BINGHAMTON
U N I V E R S I T Y
STATE UNIVERSITY OF NEW YORK

PHYSICAL FACILITIES

SUBJECT: **Addendum # 2**
Project #: WO453154
Title: Baseball Complex Archway

1 FOUNDATION PLAN

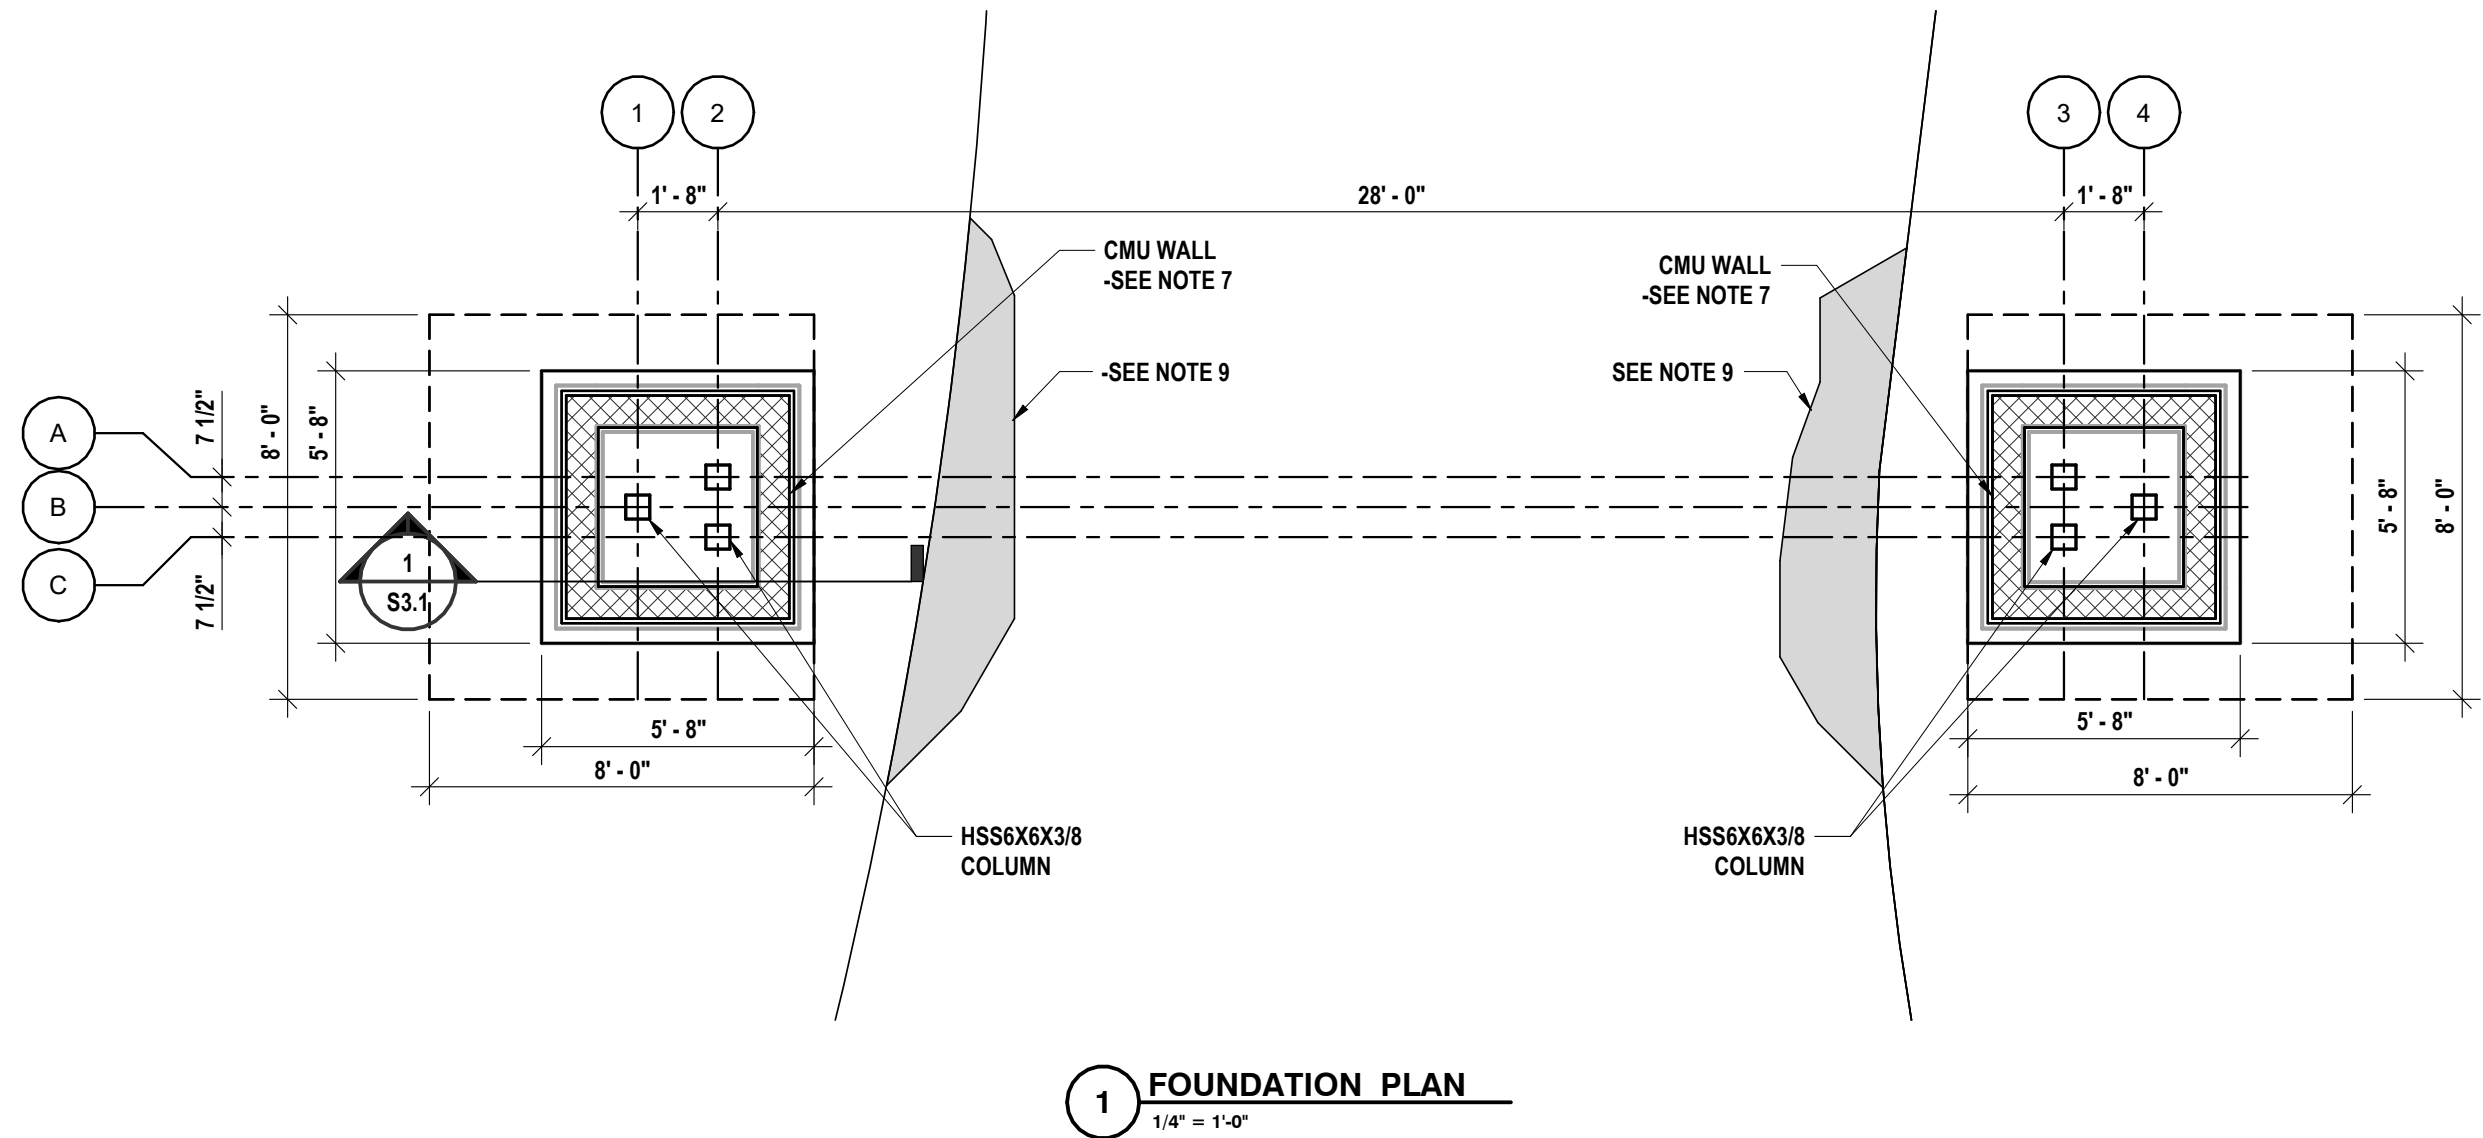
9. The documents indicate the existing concrete sidewalk is to be protected and not disturbed. This was also noted during the pre-bid meeting. Plan drawing 2/L2.1 provides layout information for the new archway construction at grade with dimensions from face of new piers to face of edge of existing concrete (the

dimensions - on the east side 1.02' and 0.96', and on the west side 1.47' and 0.96'). The footing for the piers are scheduled to be 8'-0" x 8'-0". In order to excavate and create enough room for the formwork necessary for the cast-in-place concrete it'll require undermining the existing concrete walkway and also create a potential unsafe work condition for the workers performing the forming, reinforcement work, and placing the concrete. Providing sheeting is not an option as it'll be a conflict at minimum with the layout of the footings. Should a portion of the existing walkway be removed and replaced to provide adequate space to complete the work shown? As related to Alternate No. 1, if a swath of concrete was removed and replaced, it would eliminate the need for directional drilling to get conduit/power from the east side to the west side. Please advise. *The existing walk is to remain and be protected at all times - refer to AD1-S1 in Item AD1-2 below. Should the walk become damaged it will need to be replaced in kind.*

ITEM AD1-2 Refer to S1.1 -FOUNDATION AND FRAMING PLAN

AMEND Plan 1/S1.1 per AD1-S1 as issued with this addendum.

ITEM AD1-3 Refer to S1.1 -FOUNDATION AND FRAMING PLAN

ADD Plan note 8 to 1/S1.1 that reads as follows:

“8. OFFSET FOOTING LOCATED AT GRID B/2 1’-2” TO THE WEST AND OFFSET FOOTING LOCATED AT GRID B/3 1’-2” TO THE EAST.”

ITEM AD1-4 Refer to S1.1 -FOUNDATION AND FRAMING PLAN

ADD Plan note 9 to 1/S1.1 that reads as follows:

“9. CONCRETE SLAB TO REMAIN IN PLACE AND BE PROTECTED DURING CONSTRUCTION. INFILL ANY AREA UNDER SLAB THAT WAS UNDERMINED DURING CONSTRUCTION WITH FLOWABLE FILL.”

8. OFFSET FOOTING LOCATED AT GRID B2, 1'-2" TO THE WEST AND OFFSET FOOTING LOCATED AT GRID B3, 1'-2" TO THE EAST.
9. CONCRETE SLAB TO REMAIN IN PLACE AND BE PROTECTED DURING CONSTRUCTION. INFILL ANY AREA UNDER SLAB THAT WAS UNDERMINED DURING CONSTRUCTION WITH FLOWABLE FILL.

-FOR MORE INFORMATION SEE SHEET S1.1
-ADD PLAN NOTES 8 & 9 TO 1/S1.1
